IN HOUSE REJECTION: KAIZEN

3a.8 Appearance not Good

Physical Phenomenon : **Part burnt in CO₂ welding**
Due to : Man / Machine / **Method** / Material

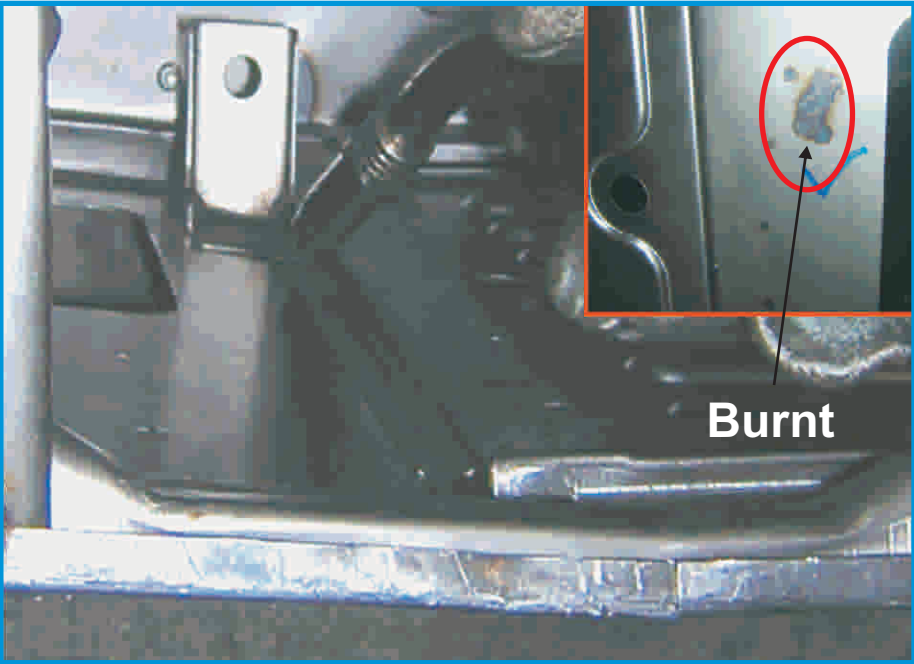
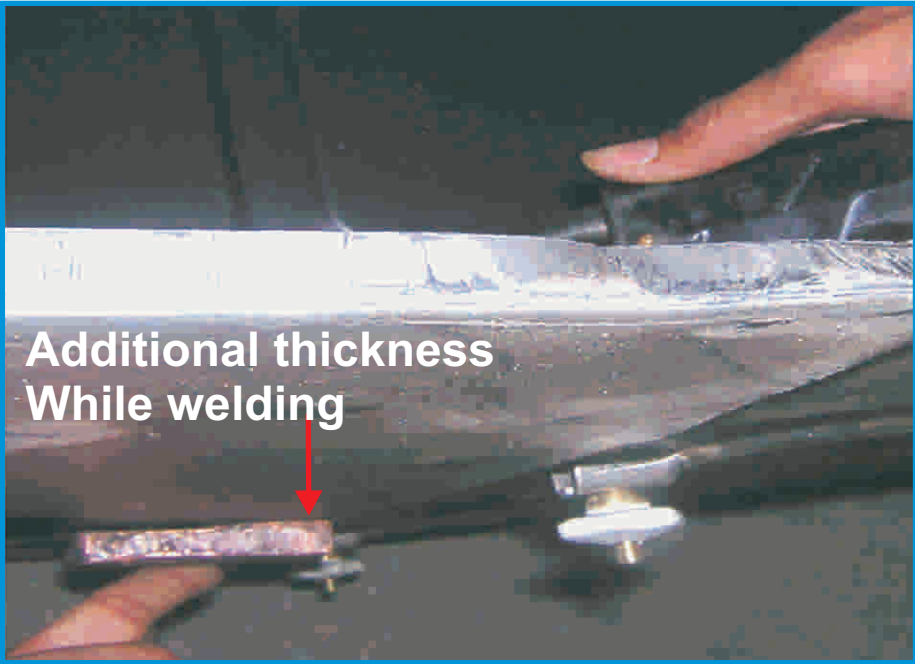
Panel burnt while CO₂ welding bracket as panel thickness is less.

Root Cause : Low thickness at welding area

Kaizen Idea : High thickness at welding area

Kaizen :Support of Copper plate to part as additional thickness while CO₂welding
